Thames Farm Action Group
Rambler Cottage, Reading Road, Lower Shiplake, OXON RG9 3PH

Reserved Matters Application no. 2 ref P20/S2808/RM-HAR

Please find attached a further report from JBA regarding the latest submission from Taylor Wimpey re Thames Farm Drainage Strategy/Condition 11 discharge.

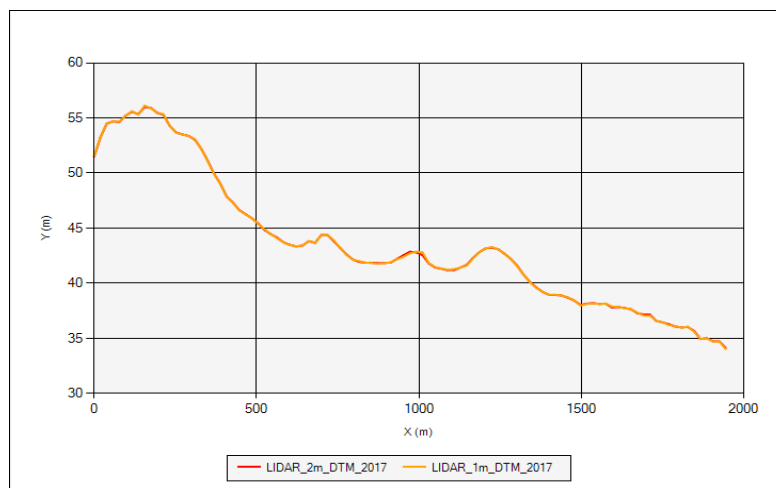
10. Apart from money/cost, there seems no reason why a pumped system has been selected over a gravity fed arrangement, given that the levels are arranged such that a gravity fed system would be achievable. There is zero evidence of any whole life costing being employed on the alternative solutions. The levels data from pumping station to outfall is shown in the table below:
